DATE: 4/10/2018	JOB NO. 1808
ATTENTION: Planning Board	
RE: Site Plan Approval	
36-64 Maplewood

RE: Application for Site Plan Review for 46 – 64 Maplewood Avenue, Portsmouth Tax Map 154 – Lot 2

On behalf of 30 Maplewood, LLC, we hereby submit Site Plans for the 46 - 64 Maplewood Avenue project for Planning Board approval. The applicant has worked to address comments throughout the process. We submitted revised plans and supporting material on February 6th to address the Technical Advisory Committee Site Plan Conditions of Approval from their January 30, 2018 meeting. The plan set has also been revised to address the Stipulations and Conditions proposed from the February 15 Staff memo. The Planning Board, at your meeting on March 15, 2018, voted to table the application to your April meeting to address the following:

DEMOLITION PLAN

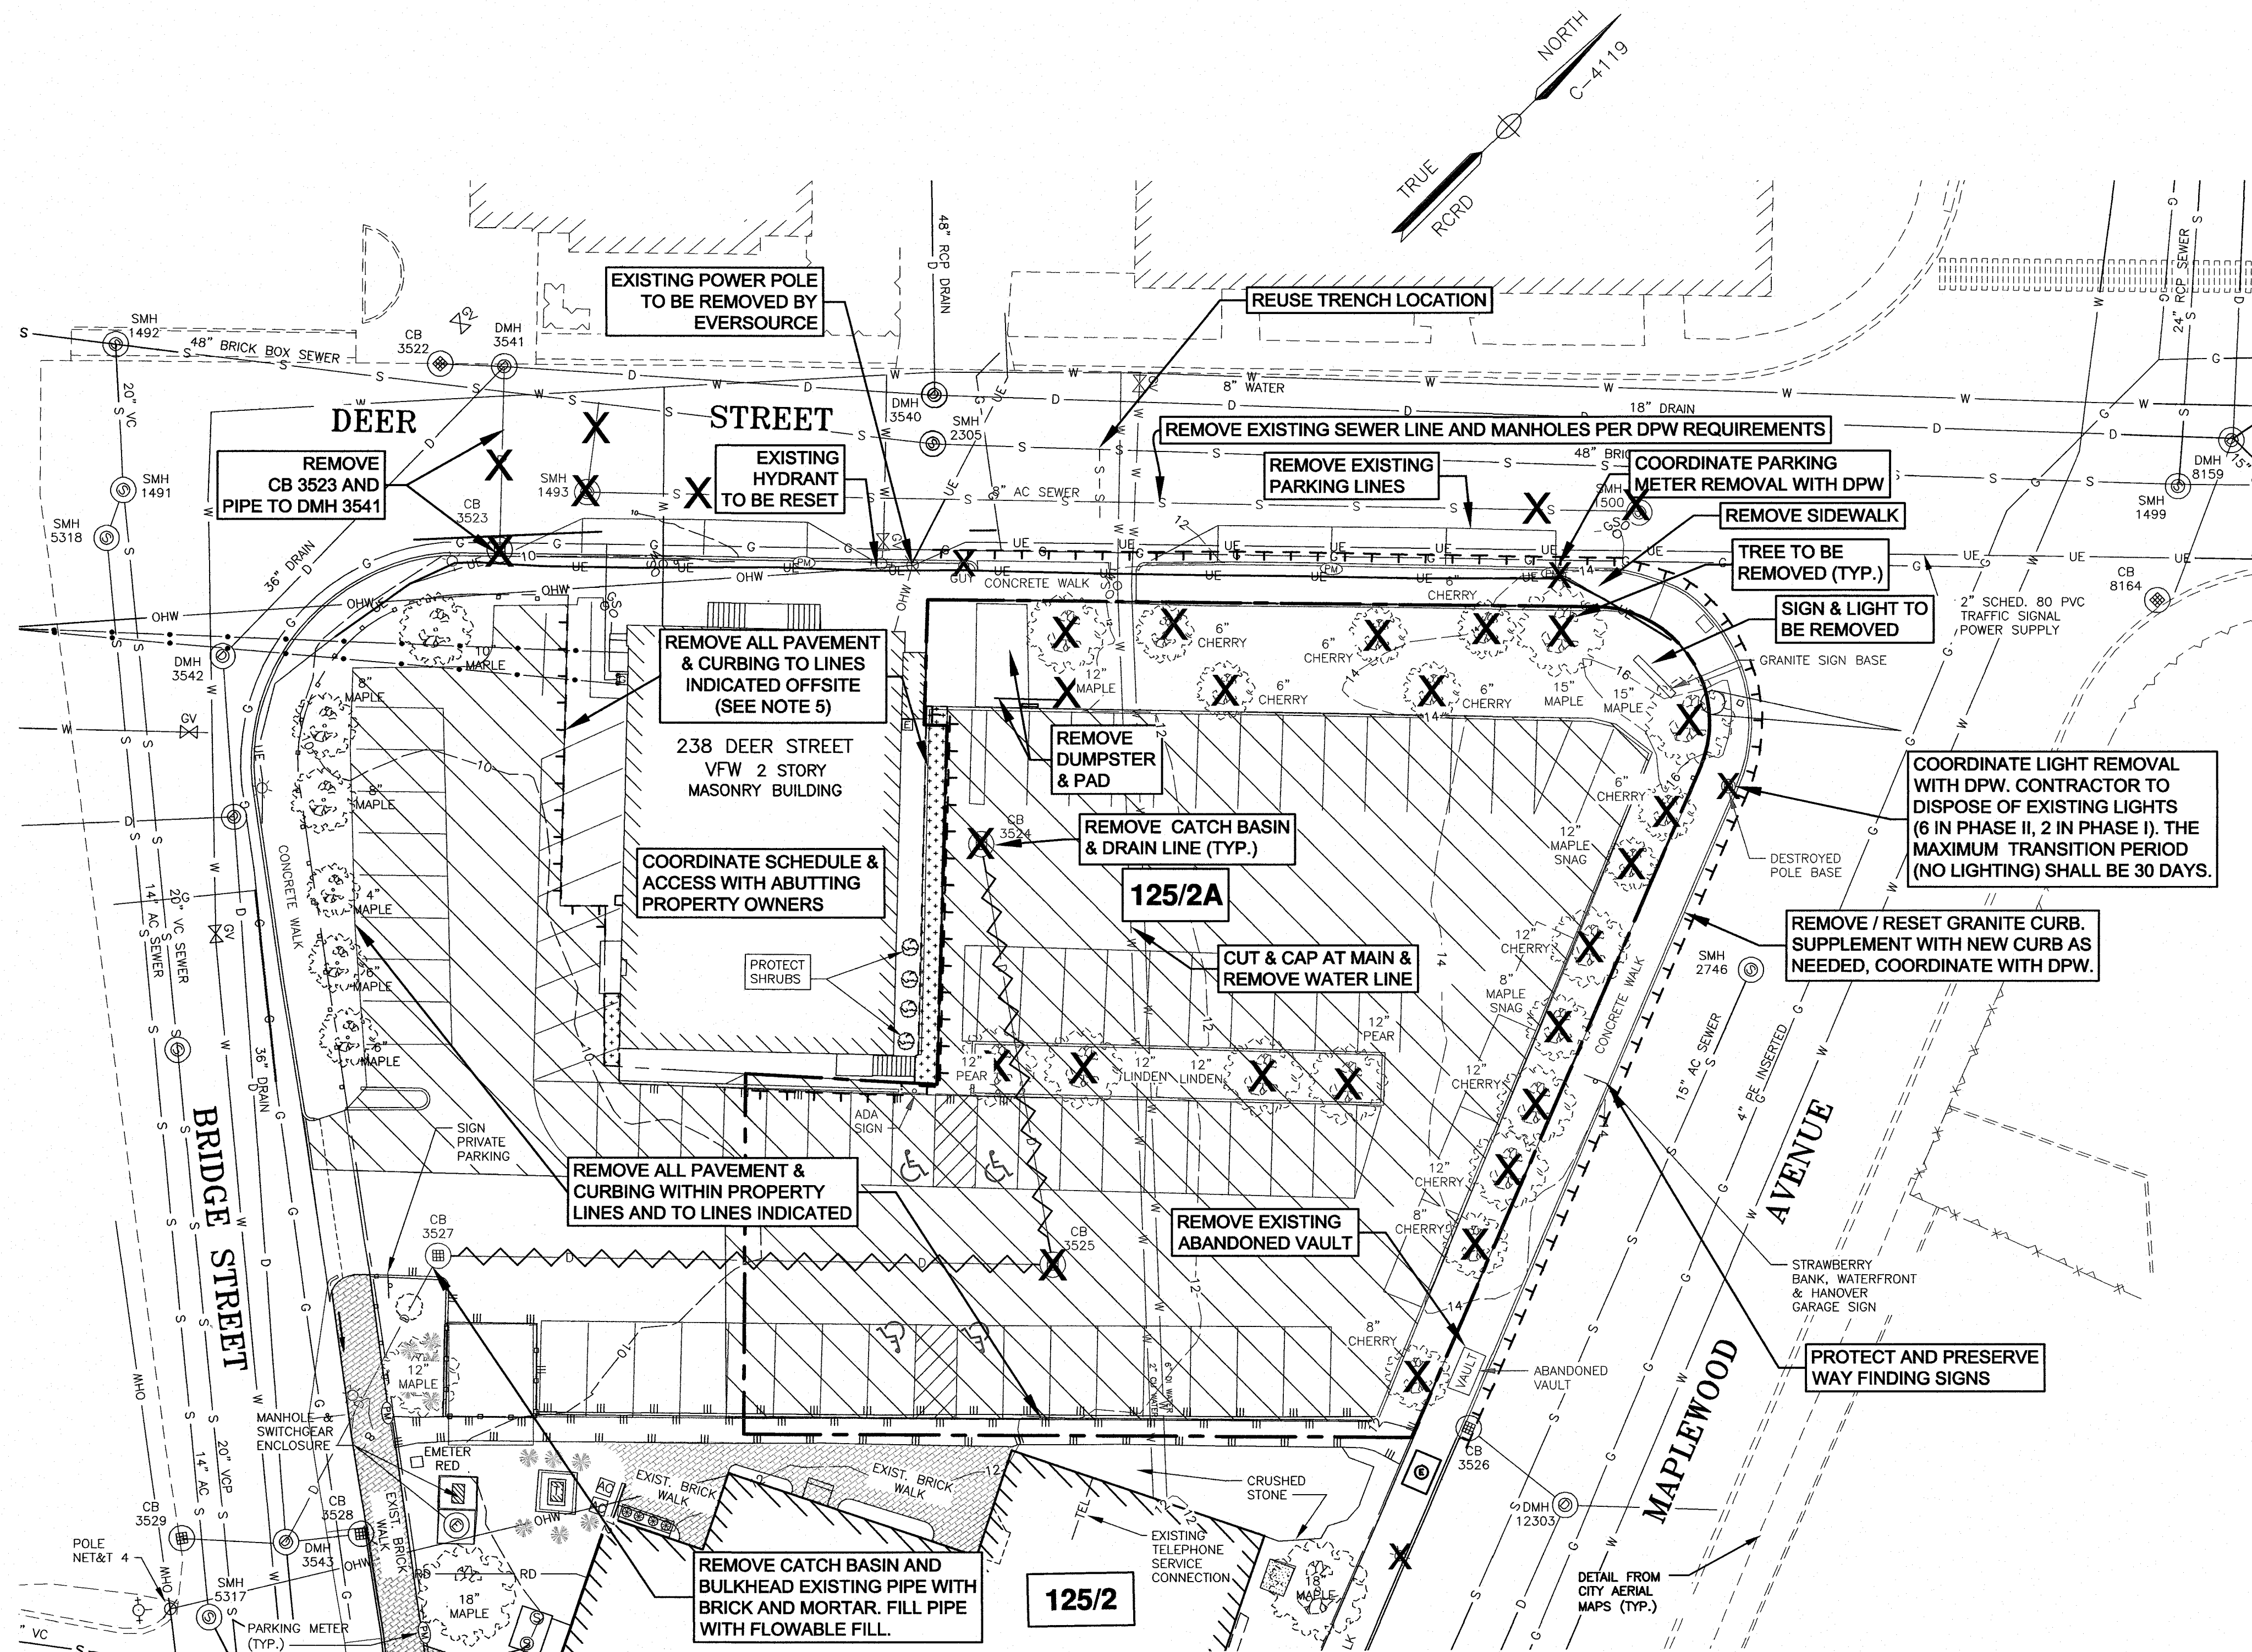
5. The Cover Sheet should reference Jim Tow for water and sewer contacts. **The Cover Sheet was revised as requested.**
6. Why is OCS#2 shown spatially where the communication vault exists? **The vault has been abandoned and will be removed, as noted on Sheet C2.**
